Special Resolution No. 1 concerning the common definitions of vehicle categories, masses and dimensions

Proposal for Amendments to the Special Resolution concerning the common definitions of vehicle categories, masses and dimensions

Submitted by the expert from the International Association of the Body and Trailer Building Industry (CLCCR) *

Figure 1
Principle/Example of Driven Trailer Axles

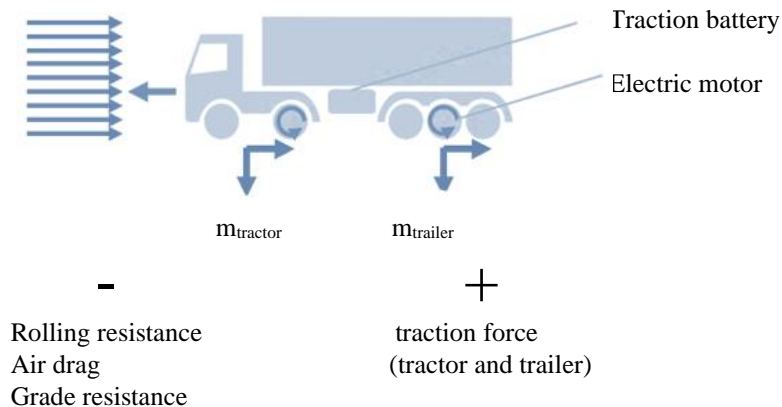
2. One of these features is a driven axle in a trailer/semi-trailer (e.g. with propulsion and/or recuperation system). Driven axles in trailers have the potential to support the motor vehicle (e.g. the tractor) during start-stop manoeuvres, during accelerating/braking and during transport of heavy loads under ambitious conditions (uphill/downhill) or may convert the kinetic energy of an axle to supply electric systems (e.g. cooling units for reefer). This leads to lower fuel consumption of the motor vehicle respectively cooling units (ergo lower CO₂ emissions) and higher agility of the whole vehicle combination.
